TENDER ADDENDUM

Project: UHN Interventional Fluoroscopy Tender Addendum #:

University Hospital of Northern British Columbia

The following information supplements and/or supersedes the "Issued for Tender" drawings issued for the above project dated February 10, 2021.

PHASE 1 - INTER FLUORO LEVEL 1 - FURNITURE, EQUIP. & FINISHES PLAN

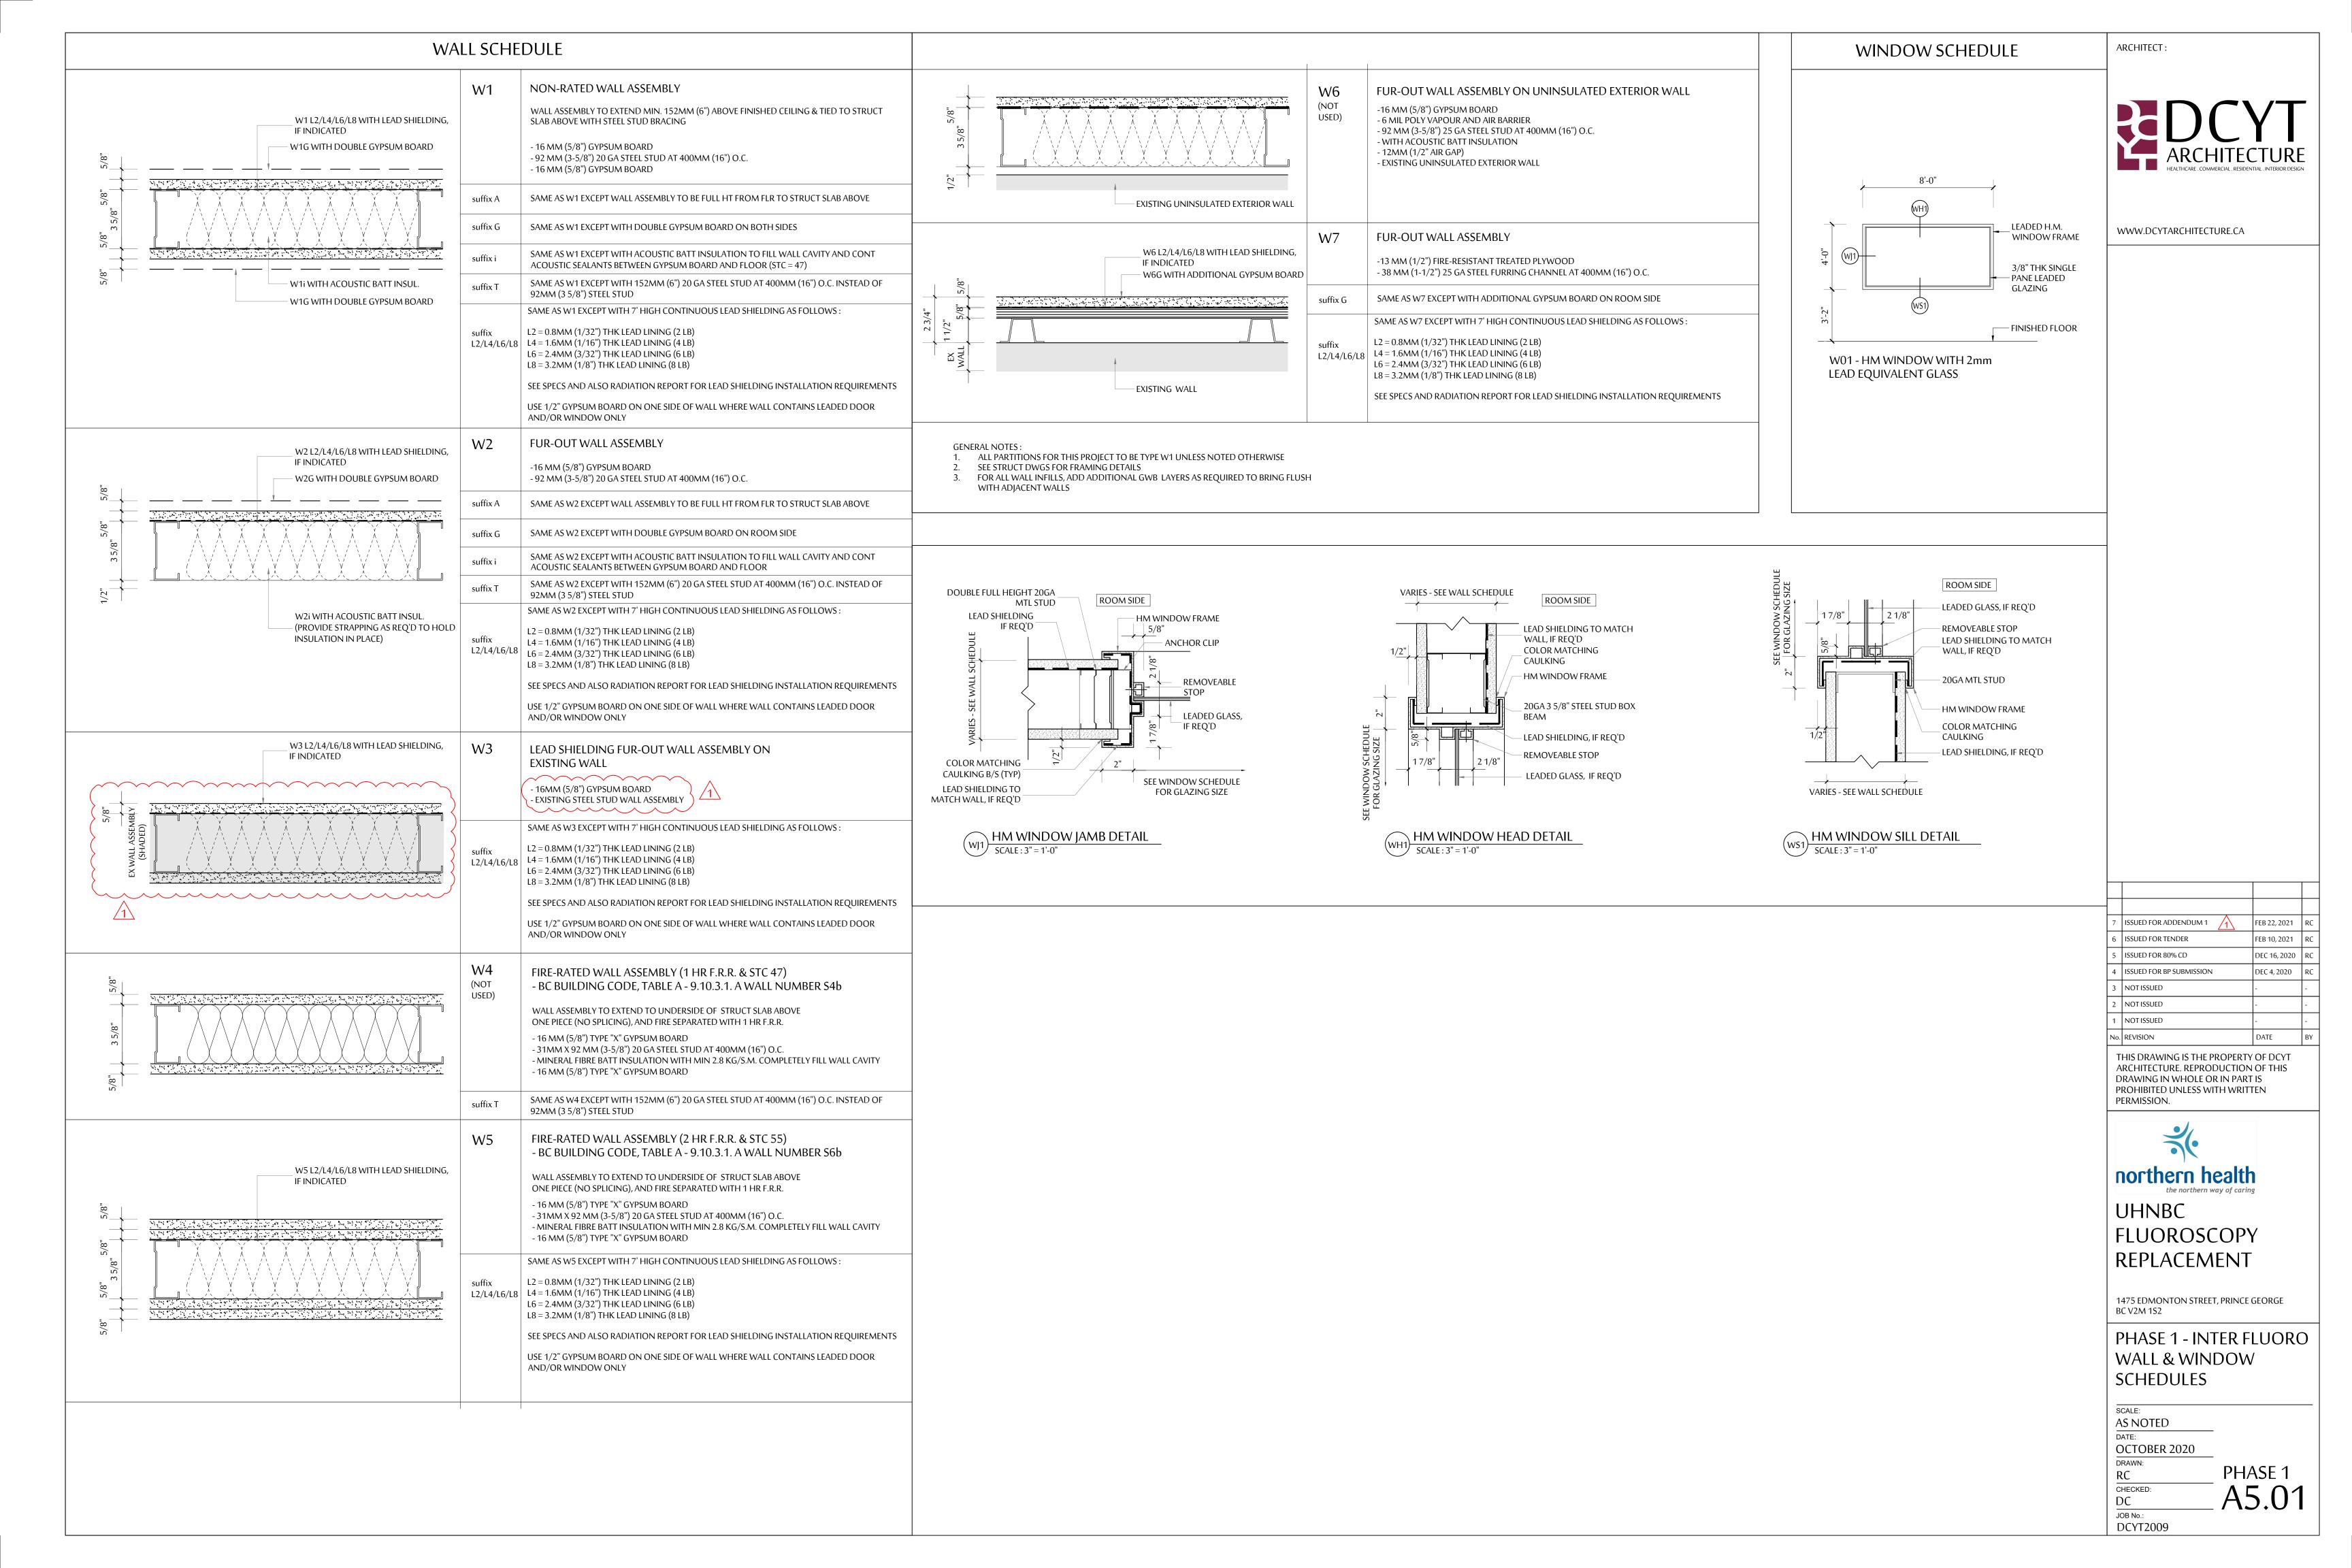
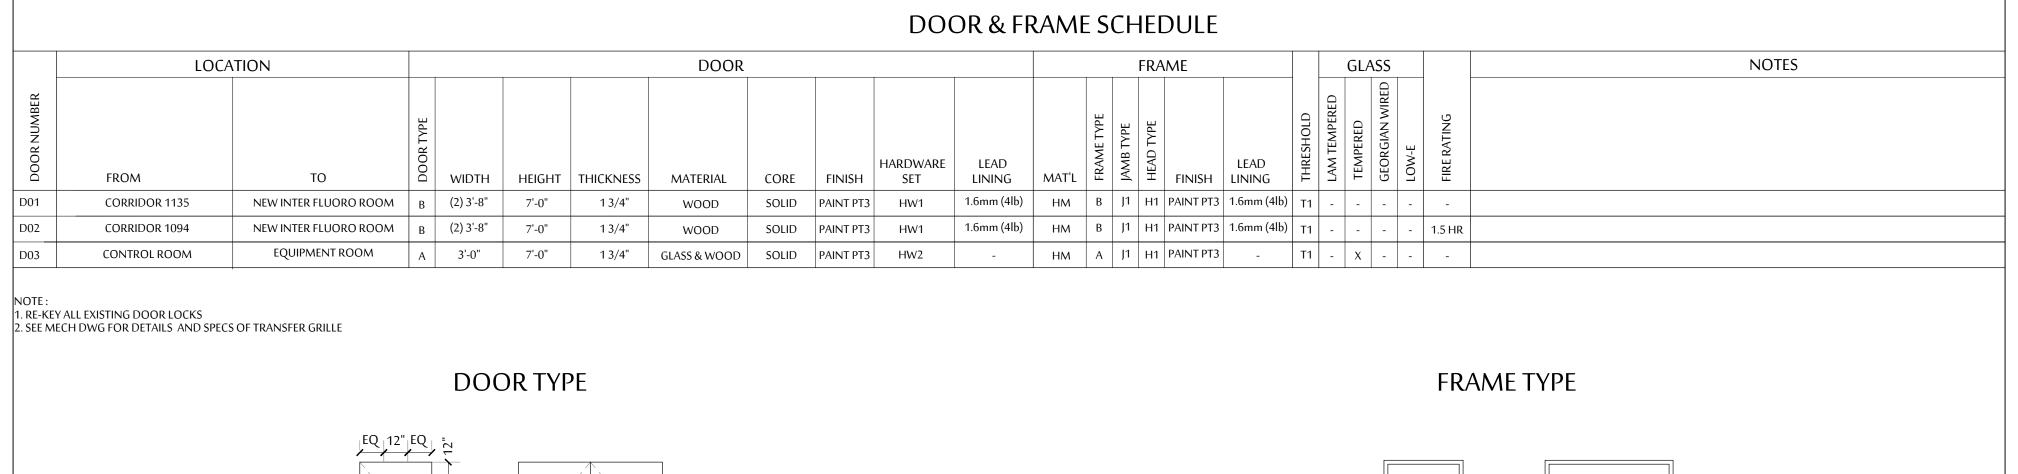
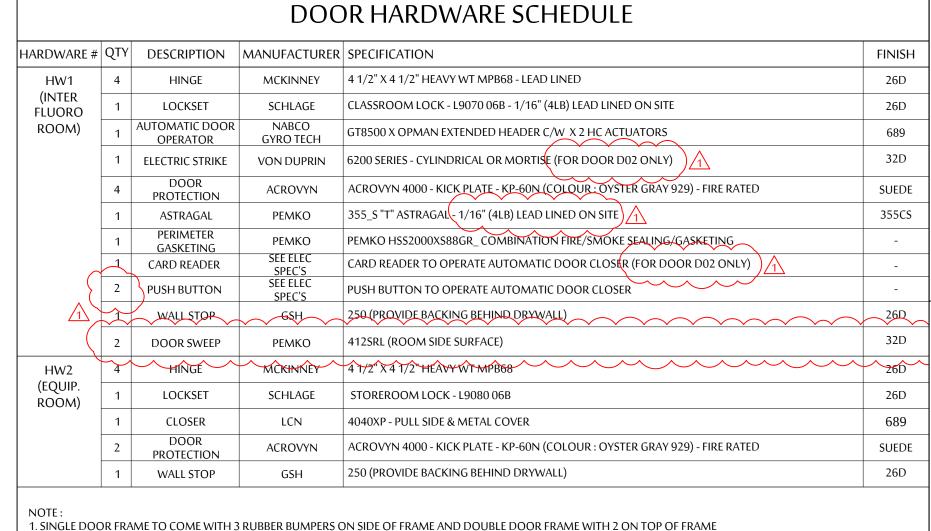
2.5.	See attached Dwg A2.03 – Level 1 – Furniture, Equip. & Finishes Plan, for millwork revisions.	
2.6.	See attached Dwg A5.01 – Wall & Window Schedules, for revised wall schedule.

PHASE 1 - INTER FLUORO MILLWORK PLANS & **ELEVATIONS**

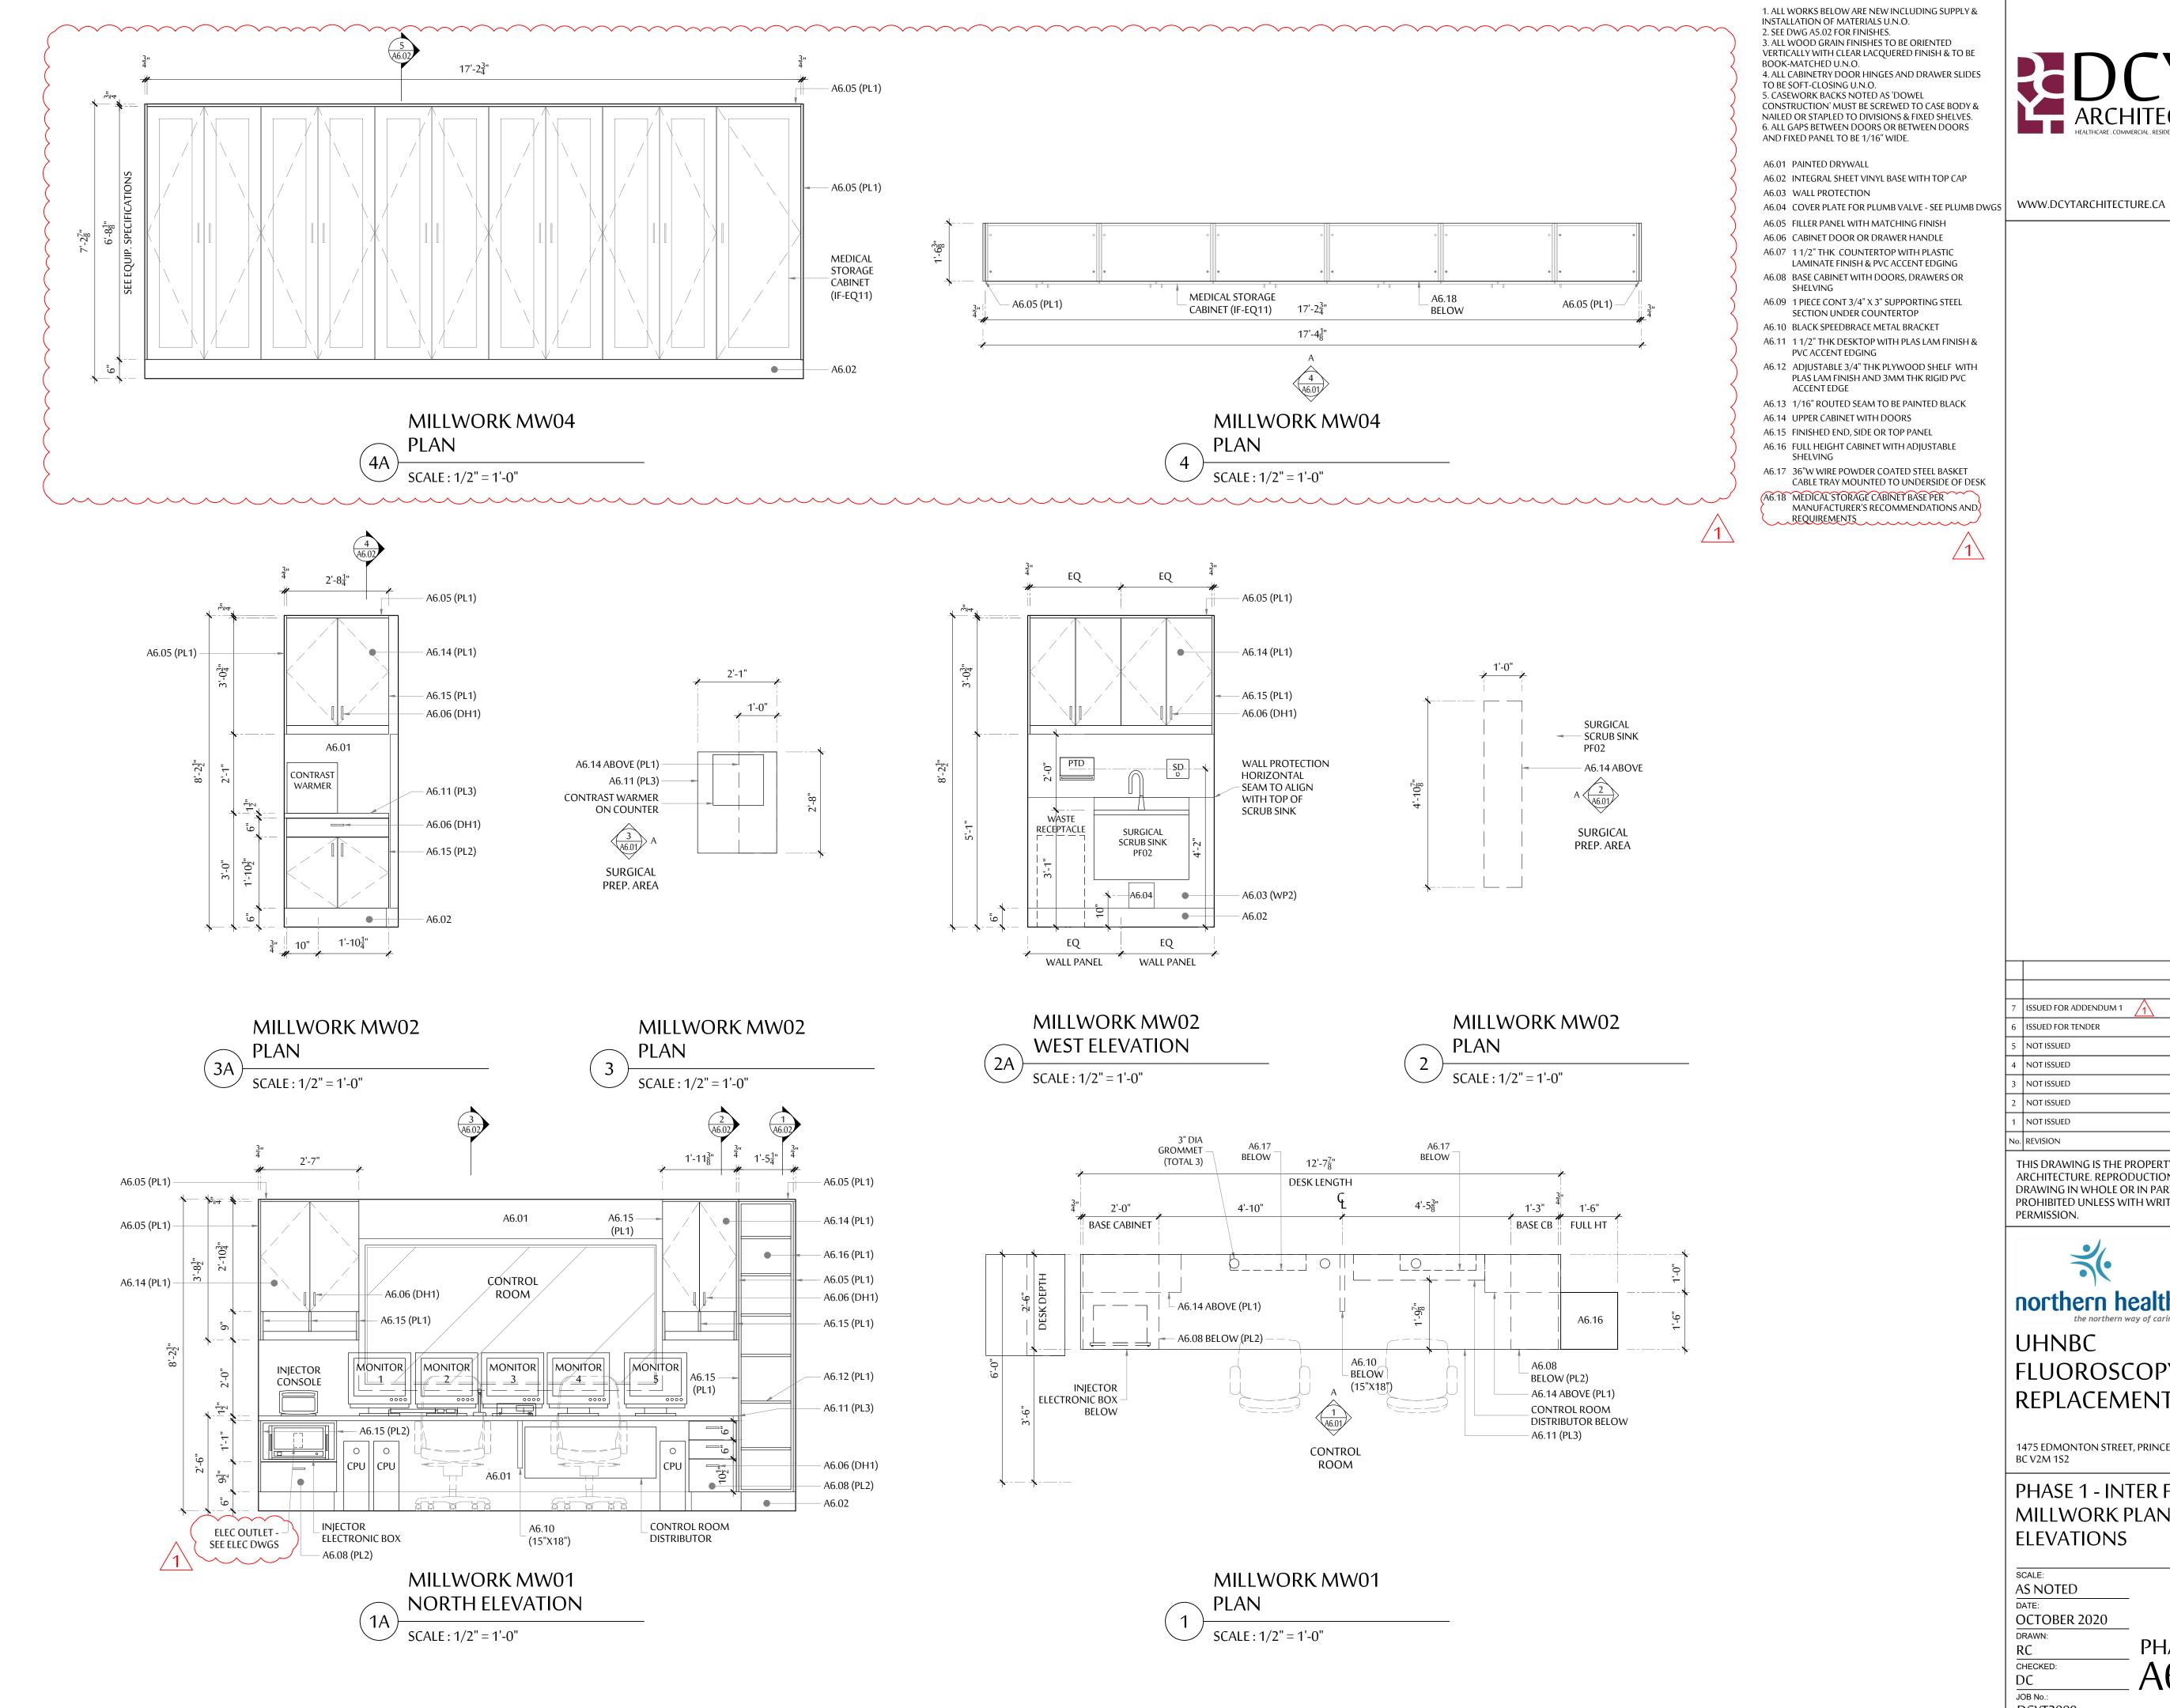
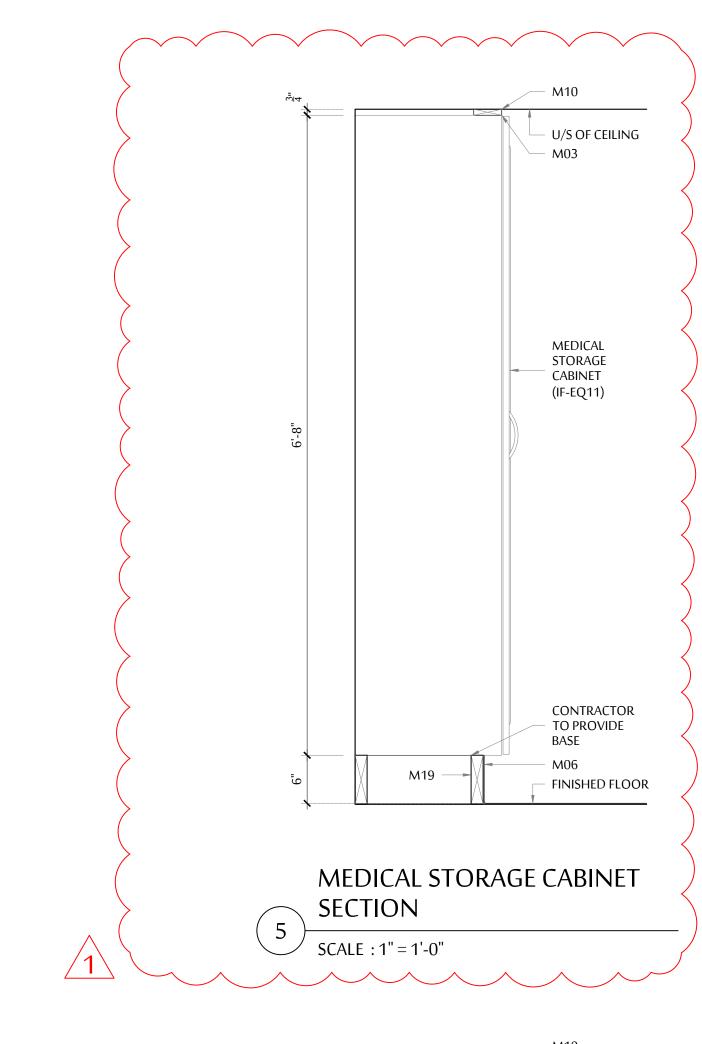
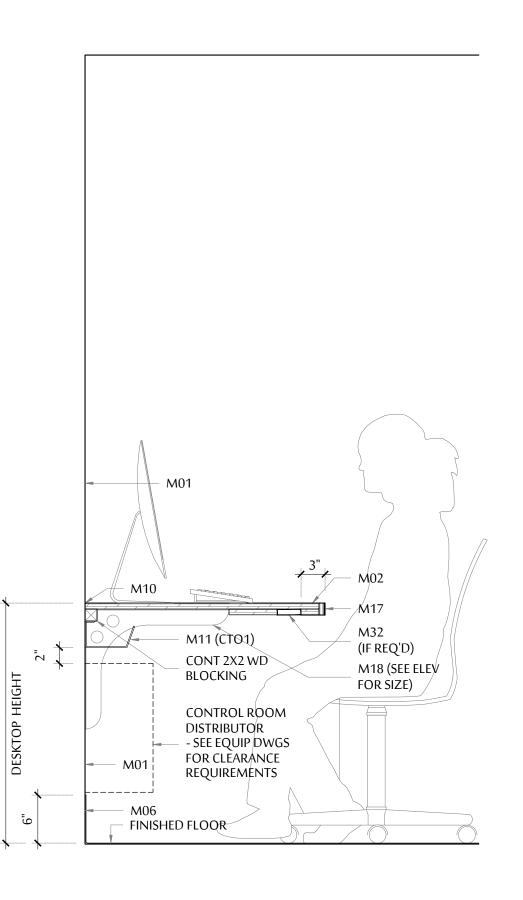
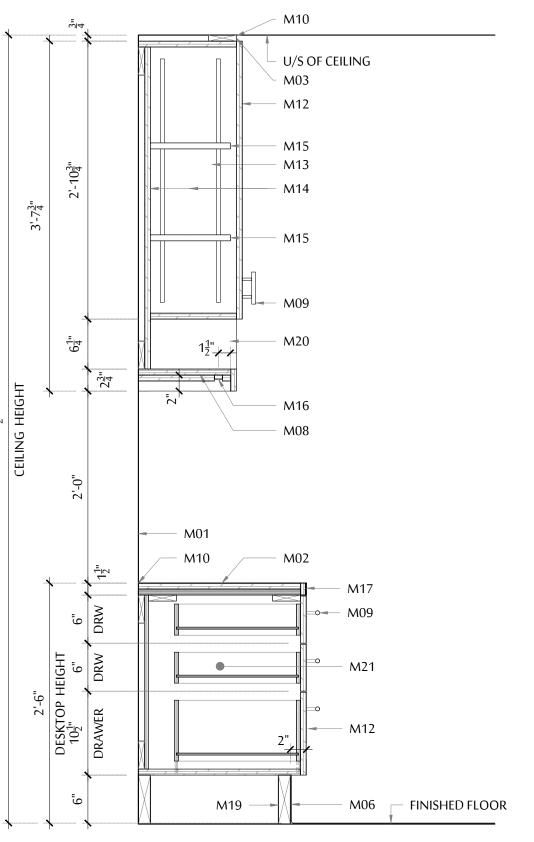
2.7.	See attached Dwg A5.02 – Door hardware, Finishes & Room Schedule, for revised door hardware schedule.	
2.8.	See attached Dwg A6.01 & A6.02 – Millwork, for millwork revisions.
